Access Compliance Report

Public Rights-of-Way

(Curb Ramps)

Intersection ID: 28903	Main Street: CAMPUS_WALK_LN	Cross Street: JOHN_KIRK_DR	Location: SW
ADA ID: E933A41CB91B	Ramp Type: PerpDiag	Initial Pass/Fail: Fail	Overall Compliance: No
Severity Score: 37.5			
Codes/Mitigation Info/Possible Solution		Field Measurements/Component Compliance

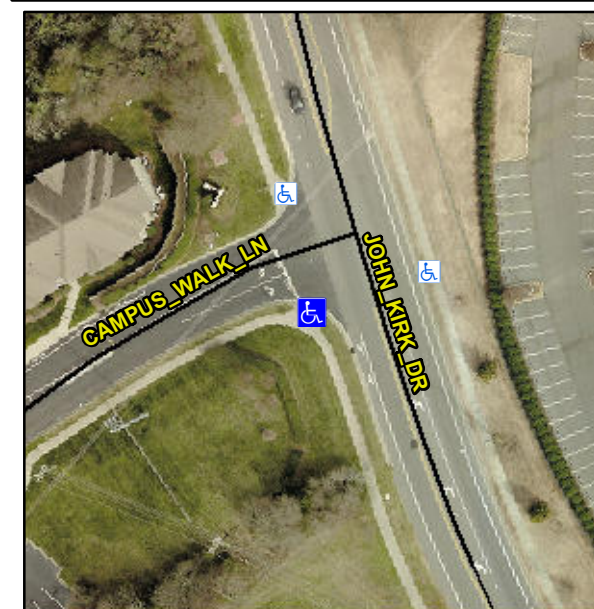
R304.2.2, R304.5.3

Compliance	Description	Data	Compliance	Description	Data
N/A	Ramp Length (in)	90.0	No	Ramp Slope (%)	20.0
Yes	Ramp Width (in)	48.0	No	Ramp XSlope (%)	6.5
N/A	Flare Type LT	N/A	N/A	Flare Type RT	N/A
N/A	Flare Slope LT (%)	N/A	N/A	Flare Slope RT (%)	N/A
N/A	Flare Traversable LT?	N/A	N/A	Flare Traversable RT?	N/A
N/A	Landing Length (in)	N/A	N/A	DWS Provided?	N/A
N/A	Landing Width (in)	N/A	N/A	DWS Contrast?	N/A
N/A	Landing Slope (%)	N/A	N/A	DWS Length (in)	N/A
N/A	Landing X Slope (%)	N/A	N/A	DWS Full Width?	N/A
N/A	Landing Curb? (Y/N)	N/A	N/A	DWS Offset (in)	N/A
N/A	Shared Landing?	N/A			
N/A	Gutter Ponding?	N/A	N/A	Gutter Slope (%)	N/A
N/A	Gutter Lip Ht (in)	N/A	N/A	Gutter X Slope (%)	N/A
N/A	Painted X Walk1?	No	N/A	Painted X Walk2?	No
	X Walk 1 Direction	To E		X Walk 2 Direction	To N
N/A	X Walk 1 Width (in)	N/A	N/A	X Walk 2 Width (in)	N/A
	X Walk 1 Slope (%)	9.1		X Walk 2 Slope (%)	2.4
	X Walk 1 X Slope (%)	1.9		X Walk 2 X Slope (%)	6.6

Remove & Replace Curb Ramp With Two New Directional Ramps or Equivalent.
